VARIANCE APPLICATION

CITY OF GAHANNA, FRANKLIN COUNTY, OHIO DESIGN REVIEW PLAN FOR THE MARKET AT ROGER'S CORNERS PARKING EXPANSION 2023

Subject: Project 1379-1391 E Johnstown Rd Variance
Response Letter

STAFF REPORT

CITY OF GAHANNA, FRANKLIN COUNTY, OHIO
 DESIGN REVIEW PLAN
FOR
THE MARKET AT ROGERS'
CORNERS
SITE PLAN

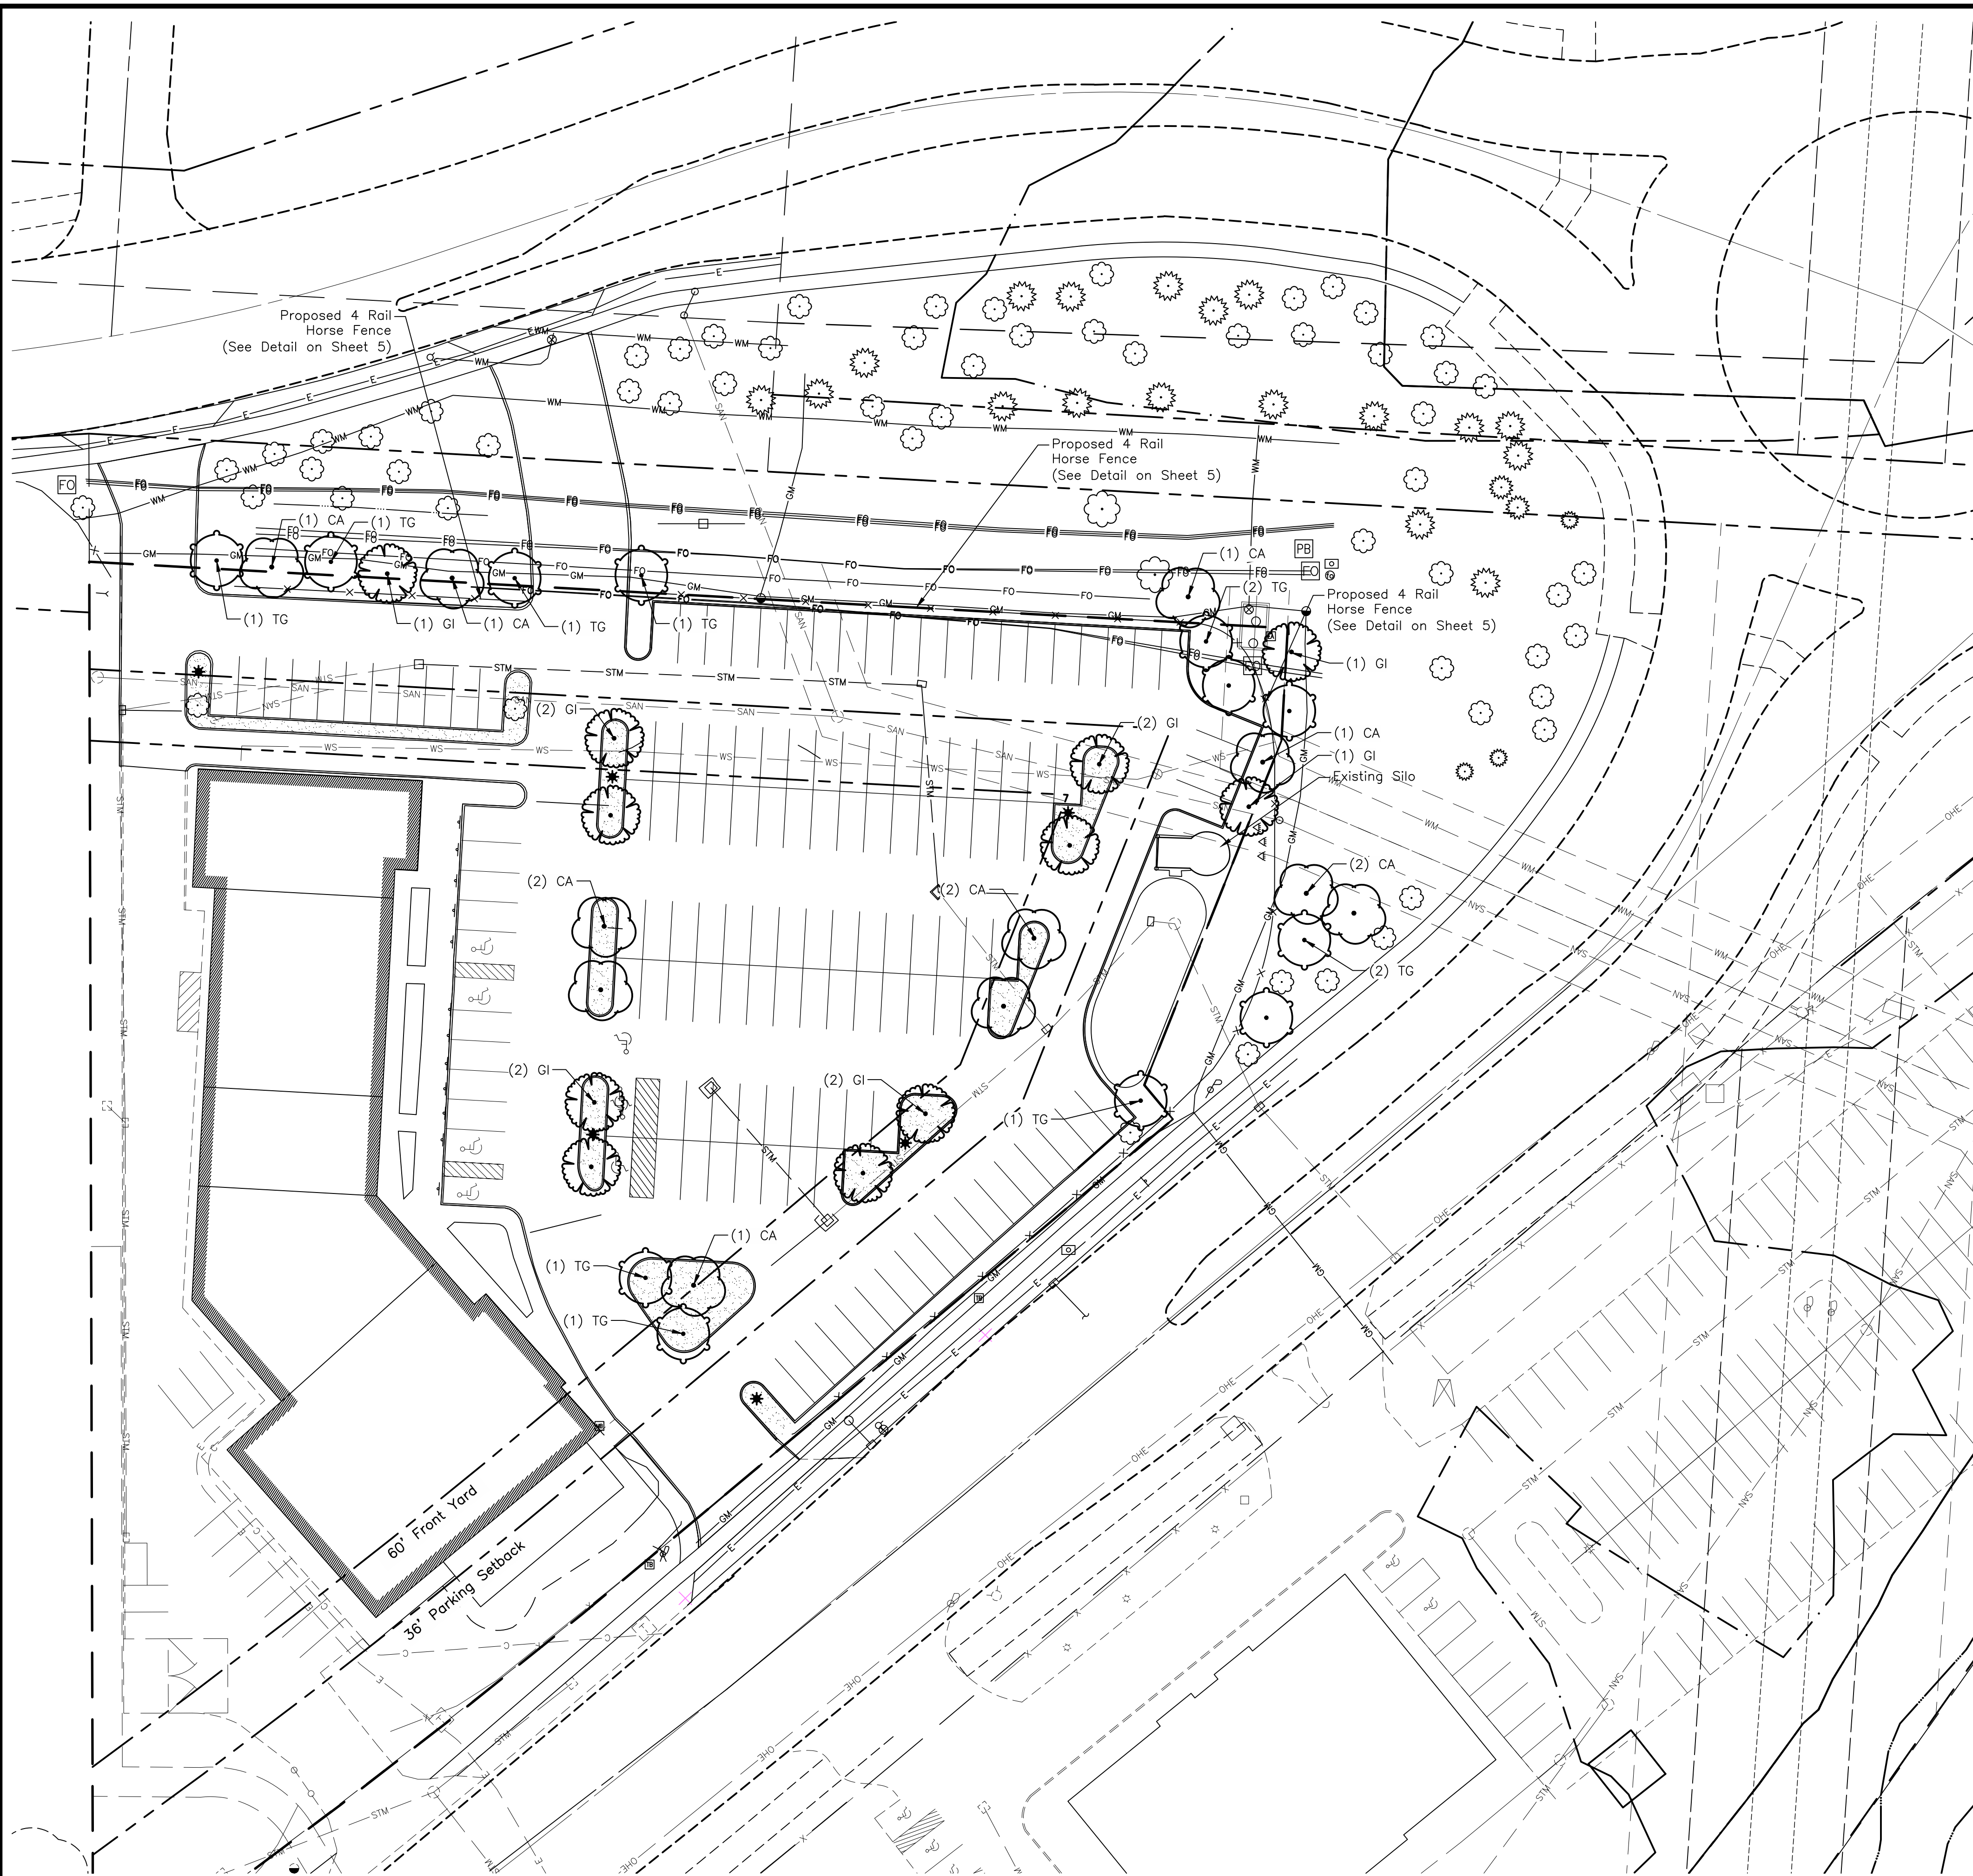
- Chapter 1163.01(a) – Parking space width
 - 9’ requested; existing parking spaces are 9’ wide
 - 10’ required by code
- Chapter 1163.08(h) – Interior landscaping

- Code requires there be a ten foot wide landscape island between two rows of parking
 - Existing parking does not meet this requirement
 - It should be noted that staff is working on code changes to eliminate this requirement. Similar projects have received variance approval.

- Chapter 1167.15(b) – Parking setback
 - Code requires a 36’ setback from right-of-way
 - Existing parking does not meet this requirement
 - Proposed parking along the frontage of Morse Rd is approximately 2.5’ from the property line. Parking along Johnstown Rd is 4’.

- Even with a reduced setback, parking in the vicinity of Morse Rd is setback substantially further from the travel lanes than typically found in Gahanna because of the substantial amount of right-of-way. City staff, including Engineering, has looked at the request and do not object to the variance.

A variance application has been submitted and reviewed by staff. The variances requested exist on the site currently but require variance approval since the site layout is changing. Planning staff supports the variance requests. We believe the variances are warranted given the shortage of onsite parking. Approving the variances allows the site to be designed in a manner that provides for enough onsite parking to safely accommodate patrons of the center.
